**RECALL: NHTSA 21V356**

**SUBJECT:** Internal Regulator Causing Overvoltage

**APPLIES TO:** Roadtrek: Zion, Zion SRT and Play models

**STEP 2:**

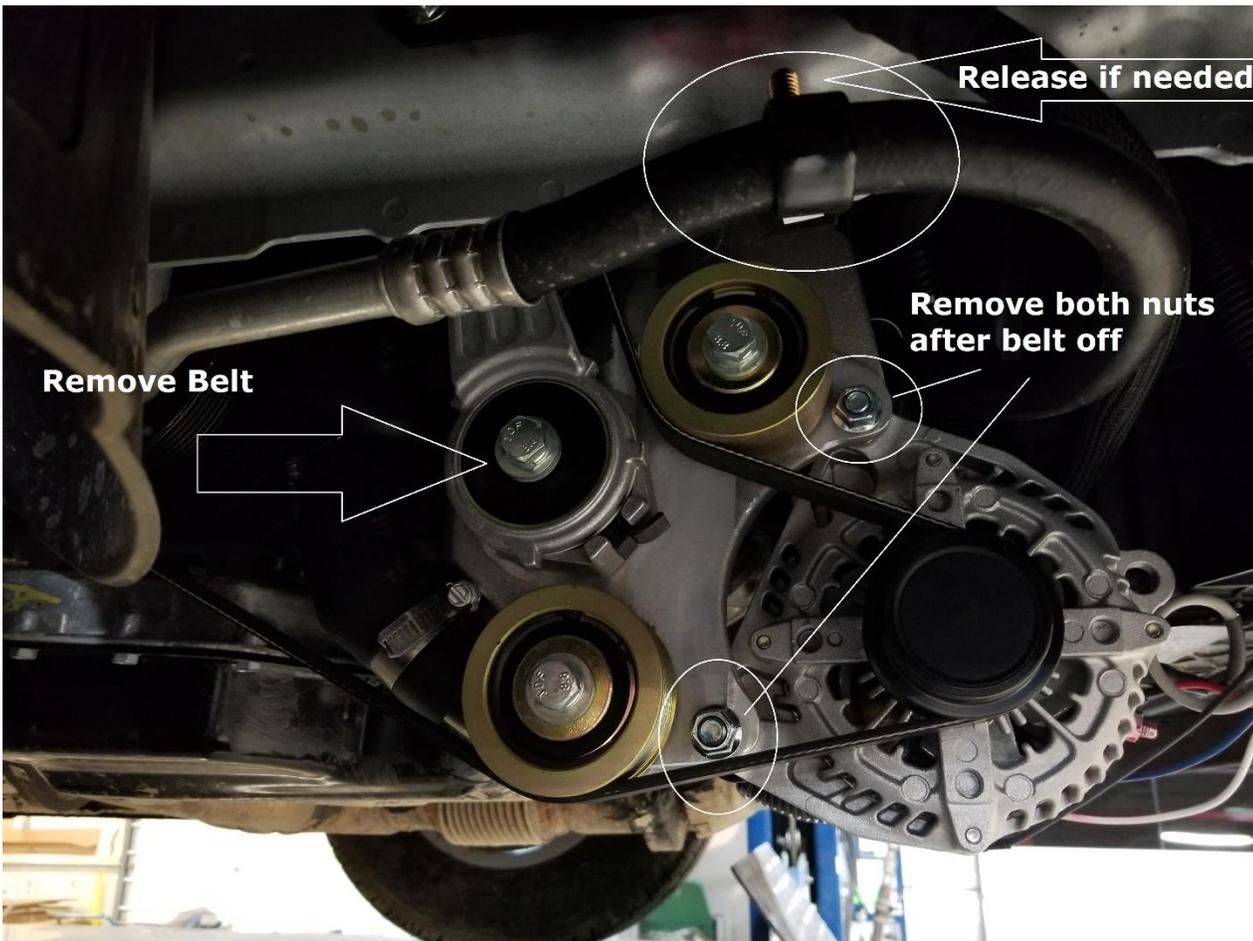
Remove and retain splash guard and hardware.

**STEP 7:**

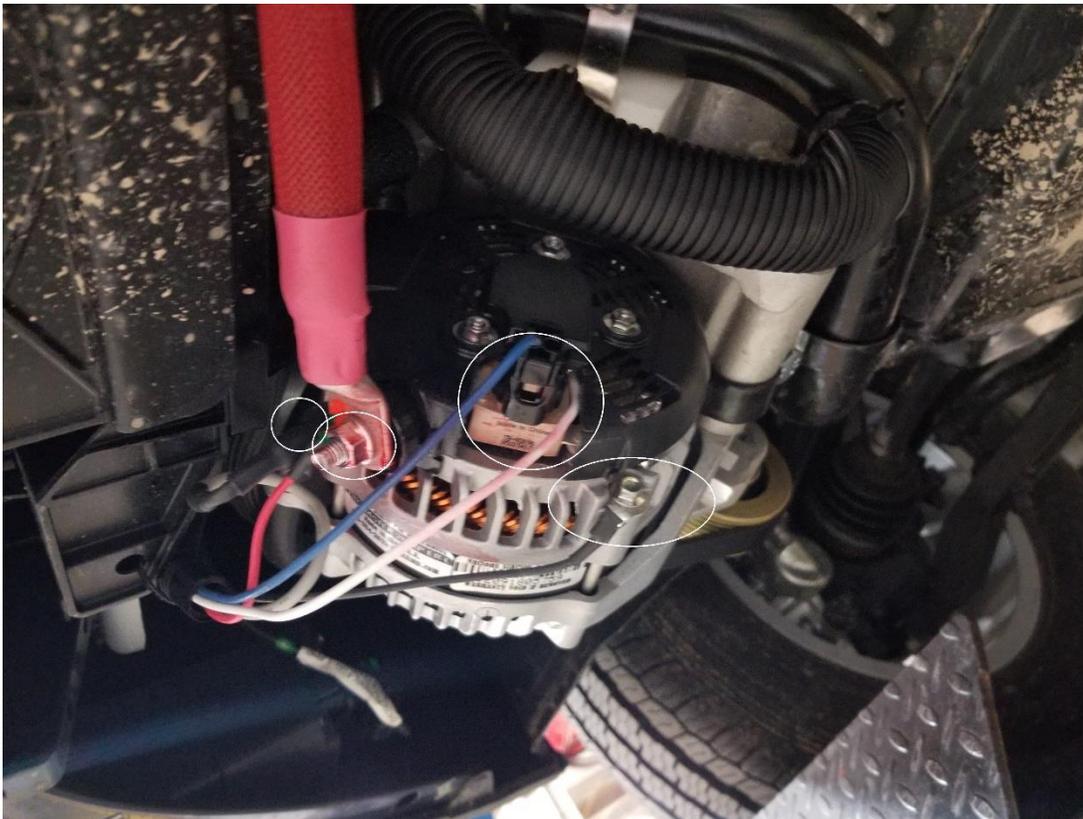
Remove wiring harness from alternator leave hanging
